**EN010117: Application by Rampion Extension Development Limited for the Rampion 2 Offshore Wind Farm**  
**The Examining Authority's Further Written Questions and requests for information**  
**Issued on Tuesday 18 June 2024**

Responses and Information Requested are due by **Deadline 5, Tuesday 9 July 2024**

Screenshot from Figure 7.2.2h (B) Woodland retention plan in the OCoCP [REP4-043] indicating W3713 shaded blue defined in the key as 'retained'.

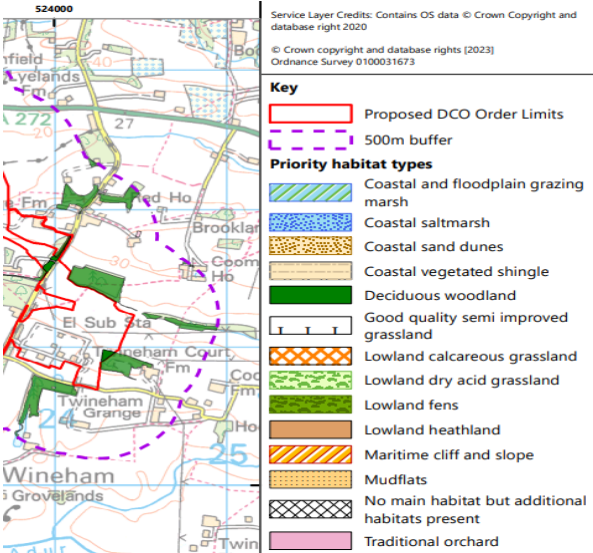
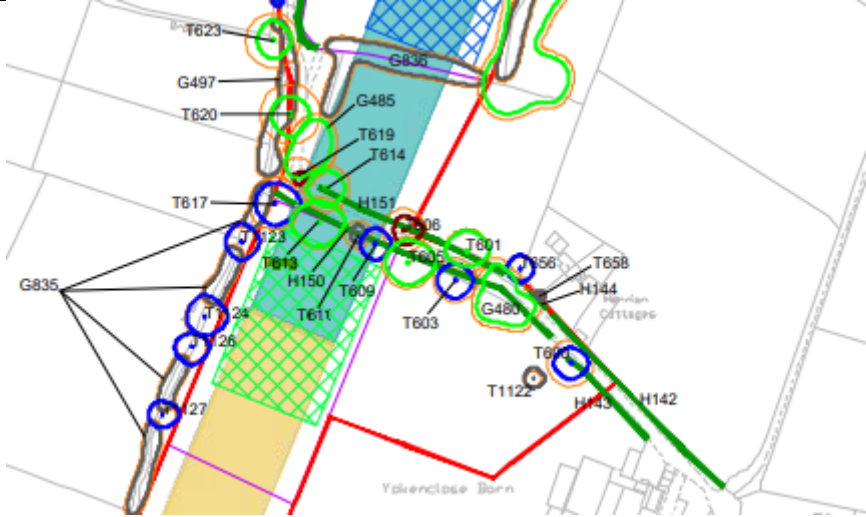
<p><b>The Applicant</b> <b>The Forestry Commission</b></p>	<p>avoid root damage. Confirm whether the Applicant intends to provide further evidence the relation to this matter.</p> <p><b>The Forestry Commission</b></p> <p>Provide a response if required.</p>
<p>TE 2.3</p>	<p><i>Priority Habitats - Potential Loss of Deciduous Woodland</i></p> <p><b>The Applicant</b> <b>West Sussex CC</b> <b>The Forestry Commission</b></p>	<p><b>The Applicant</b></p> <p>Comment on the West Sussex CC response [REP4-086] at Deadline 4 to TE1.6 which states:</p> <p><i>“The Woodland Retention Plan, Figure 7.2.2h (B) of the OCoCP [REP4-043], identifies the area of deciduous woodland status within the National Grid Bolney substation as being retained (ref. W3713). This finding is contrary to that stated within the Applicant’s response, as well as plans shown within inset 45 of the Arboricultural Impacts Plan found within the Arboricultural Impact Assessment [APP-194], as well as what can be achieved within the indicative plan for the AIS extension option without adverse impact (as shown within the Design and Access Statement). [REP3-013]. Therefore West Sussex CC remains unsatisfied that the impact on deciduous woodland, a priority habitat, are at all clear at this location.”</i></p> <div style="display: flex; align-items: flex-start;">  <div style="margin-left: 20px;"> <p>Screenshot from Inset 45 of the updated Arboricultural Impact Assessment submitted at Deadline 4 [REP4-037] indicating a section of W67 (trees not surveyed in detail) indicated in the key as ‘trees to be removed’ (indicated in red)</p> </div> </div>

Screen shot from Figure 7.2.6n Combined Vegetation retention Plan Woodland retention plan in the OCoCP [REP4-043] indicating W3713 shaded dark pink defined in the key as 'unaffected'.

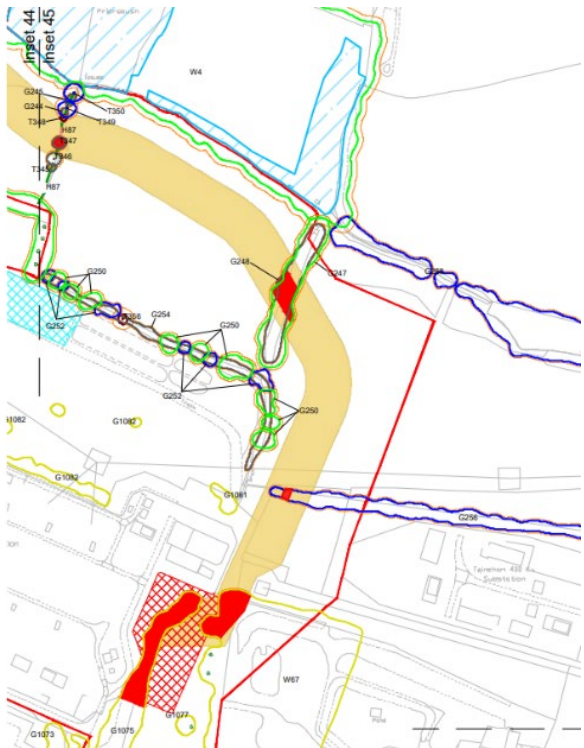
<p><i>T611, T613 &amp; T617 - Pedunculate Oaks of Middle / Mature Age above a Trenchless Crossing</i></p> <p><b>The Applicant</b></p>	<p>The Applicant responded in [REP3-051] stating:</p> <p><i>“An updated version of Appendix 22.16: Arboricultural Impact Assessment, Volume 4 of the Environmental Statement (ES) [APP-194] will be submitted at Deadline 4 to show these trees as retained. These trees were originally shown as lost on a precautionary basis as the limit of deviation for the trenchless crossing compound TC-22a which overlapped with the root protection areas. However, the Applicant can now confirm that these trees (T609, T611, T613 &amp; T617) would be retained as part of the Proposed Development”.</i></p> <p>However, the updated Arboricultural Impact Assessment submitted by the Applicant at Deadline 4 [REP4-037] lists trees T609 and T611 (Pedunculate oak of middle age) and T613 and T617 (Pedunculate oak of mature age), in Table 7-8 Possible tree removal due to alternative HDD crossings and Limits of Deviation, which is inconsistent with the response the Applicant gave to the Examining Authority’s question TE 1.9 and also inconsistent with the screenshot of Inset 34 of Annex 2 of the Arboricultural Impact Plan [REP4-037], shown below, which indicated the trees would be retained.</p>

<p>Explain this apparent inconsistency and confirm how these trees would be treated, ensuring if necessary, that the Arboricultural Impact Assessment Table 7-8 is updated and resubmitted accurately at Deadline 5.</p>
TE 2.5	<p><i>Potential loss of Category A Trees</i></p> <p><b>The Applicant</b></p>	<p>Comment on the West Sussex CC response [REP4-086] at Deadline 4 to TE1.7 which states:</p> <p><i>“Whilst welcomed to hear that the Applicant carried out a tree survey prior to determining the substation location and that veteran trees and priority habitats were considered, the Applicant’s response lacks confidence that assigned tree values in accordance with BS5837:2012 were a consideration for selection of any substation location. The location has a proposed loss of 11 of the 14 ‘A category’ trees identified across the entire DCO Limits”.</i></p> <p>Justify the proposed loss of 11 of the 14 ‘A category trees’ identified within the DCO limits and explain what other alternatives to the proposed tree loss at the proposed Oakendene</p>

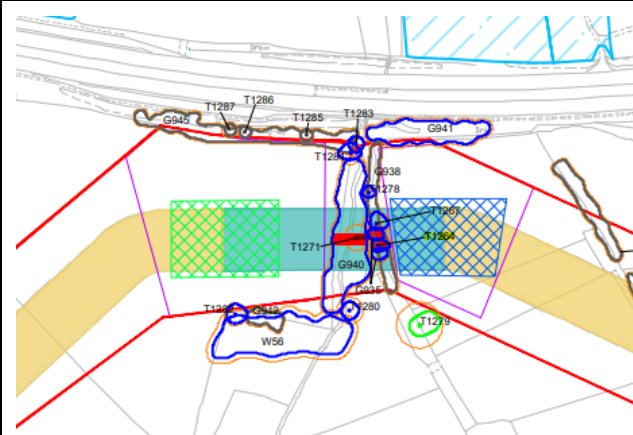
“...Where a trenchless crossing is used vehicular access will not be required other than in a small number of places where a haul road is still required (as shown on the VRP)...”.

If the reason is in relation to construction access, explain in detail for each of the examples below:

- a) Why access cannot be gained from the haul road from the open cut section as for many other trenchless crossings.
- b) What alternatives have been explored.
- c) How the mitigation hierarchy has been followed at these locations.

Screen shot taken from Inset 7 of Annex 2 Arboricultural Impact Plan of the Arboricultural Impact Assessment Revision B [REP4-037].

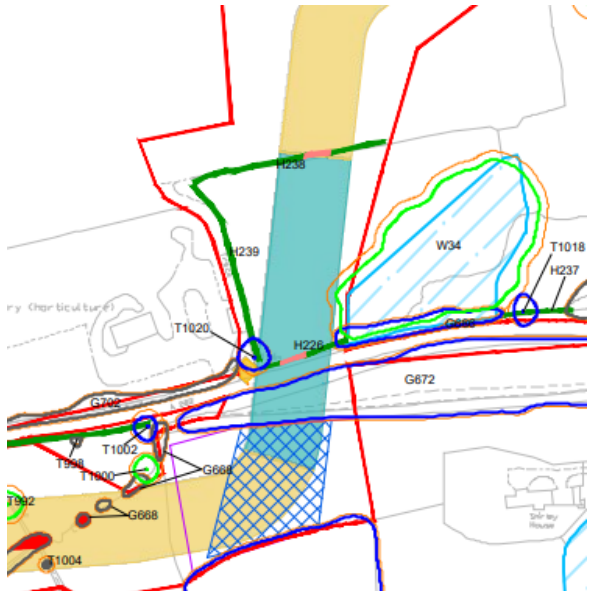
- a) The reason for the proposed removal of the trees.
- b) What alternatives have been explored.
- c) How the mitigation hierarchy has been followed at these locations.

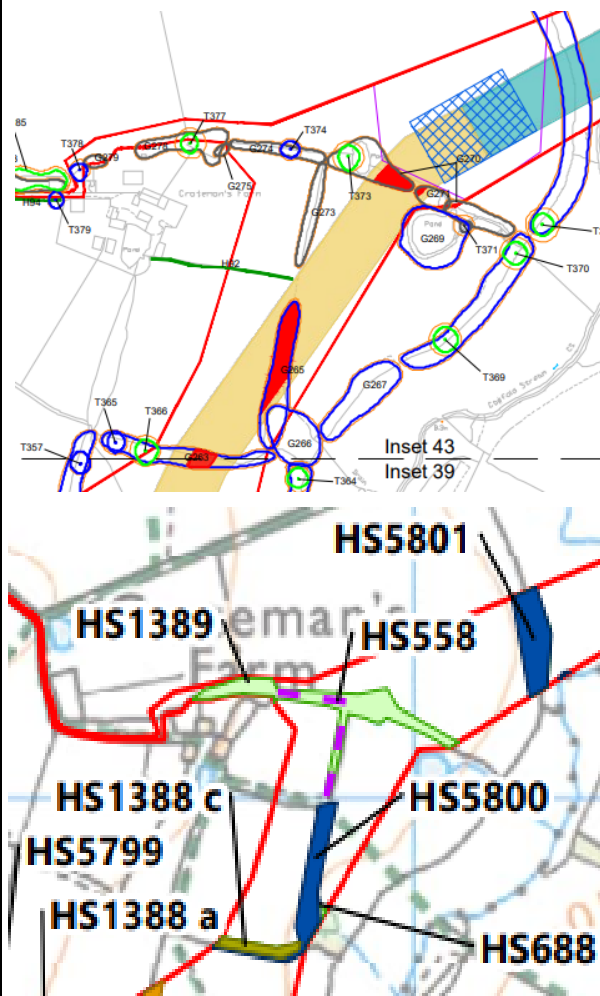
<p>D</p> 	<p>Explain and justify why the access point is proposed through G630 and not taken off the road beyond G630 to the east (appreciating this is outside the proposed DCO limits). Explain why the DCO red line boundary has not been defined in such as way to allow access off the road without going through G630.</p> <p>Screen shot taken from Inset 24 of Annex 2 Arboricultural Impact Plan of the Arboricultural Impact Assessment Revision B [REP4-037].</p>
		<p>E</p> 	<p>Explain and justify why the pink section of hedgerow H226 is proposed to be removed and why the trenchless crossing cannot be extended very slightly to extend past H238.</p> <p>Screen shot taken from Inset 28 of Annex 2 Arboricultural Impact Plan of the Arboricultural Impact Assessment Revision B [REP4-037].</p>

Screen shot taken from Inset 43 of Annex 2 Arboricultural Impact Plan of the Arboricultural Impact Assessment Revision B [REP4-037].

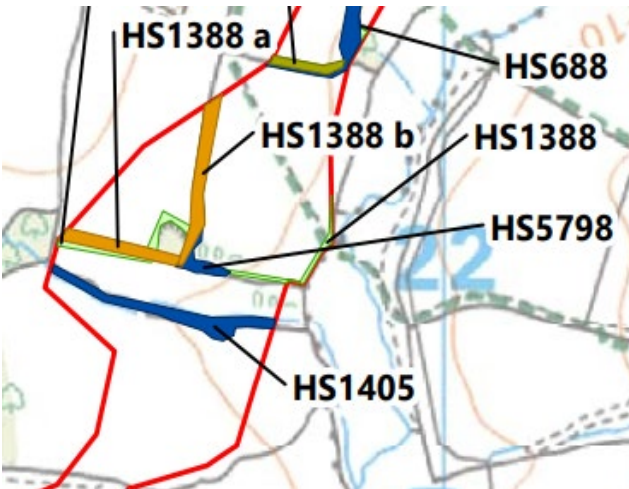
i) Explain the apparent inconsistency between the red section of G265 which are marked as trees to be removed whilst HS5800 / HS688 are marked as scrub features to be retained from Figure 7.2.3j Scrub retention plan and Figure 7.2.6m on Combined Vegetation retention plan which appear to be in the same location.

ii) Explain why G278, G274, G273 and G270 have been classified “as unsuitable for retention” according to the inset key, which are also marked as HS1389 and HS558 on Figure 7.2.3j identified as being cleared to 30m and justify their proposed clearance.

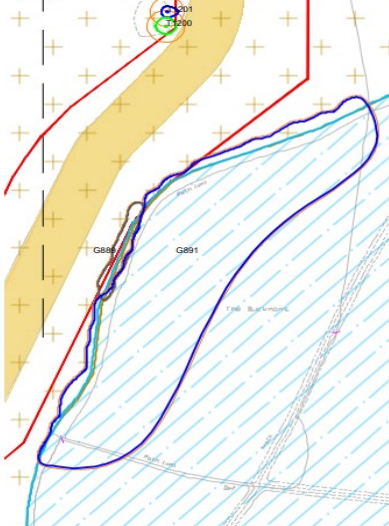
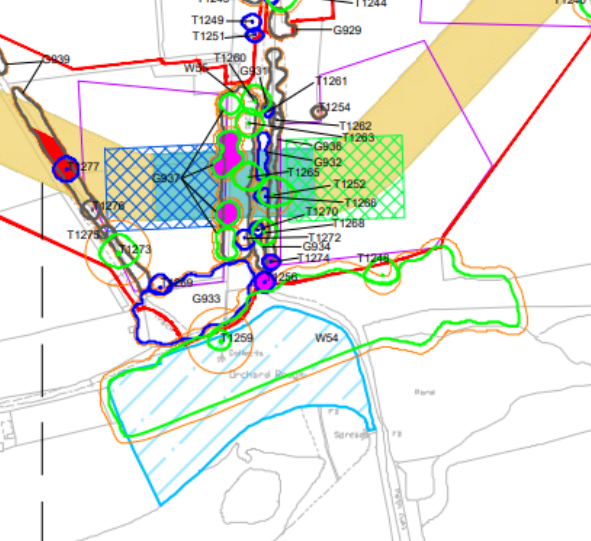
TE 2.20	<p><i>25m Buffer Zone for Ancient Woodland - Accesses A-42, A-56 and A-57</i></p> <p><b>The Applicant</b></p>	<p>Paragraph 5.6.18 of the OCoCP [REP3-025] states there are three accesses where construction works are proposed take place within 25m of ancient woodland access A-42, A-56 and A-57.</p> <ul style="list-style-type: none"> <li>a) Confirm what alternatives to these three access locations have been considered.</li> <li>b) Provide details on how the mitigation hierarchy has been followed at these three locations.</li> </ul>

<p>b)</p>  <p>South of the proposed Oakendene substation site. If the intention is to carry out a form of activity within 25m of ancient woodland here, explain in detail what that activity could be. If no activity would occur, justify the reason for the land being within the DCO redline boundary.</p> <p>Screen shot taken from Inset 44 of Annex 2 Arboricultural Impact Plan of the Arboricultural Impact Assessment Revision B [REP4-037]. Ancient woodland indicated by light blue shaded area.</p>
		<p>c)</p>  <p>If the intention is to carry out a form of activity within 25m of ancient woodland here, explain in detail what that activity could be. If no activity would occur, justify the reason for the land being within the DCO redline boundary.</p> <p>Screen shot taken from Inset 32 of Annex 2 Arboricultural Impact Plan of the Arboricultural Impact Assessment Revision B [REP4-037]. Ancient woodland indicated by light blue shaded area.</p>

d)		<p>Area of ancient replanted woodland directly to the east of Angmering Park Farm, south of Michelgrove and to the west of Patching Hill.</p> <p>If the intention is to carry out a form of activity within 25m of ancient woodland here, explain in detail what that activity could be. If no activity would occur, justify the reason for the land being within the DCO redline boundary.</p> <p>Screen shot taken from Inset 12 of Annex 2 Arboricultural Impact Plan of the Arboricultural Impact Assessment Revision B [REP4-037]. Ancient woodland indicated by light blue shaded area.</p>
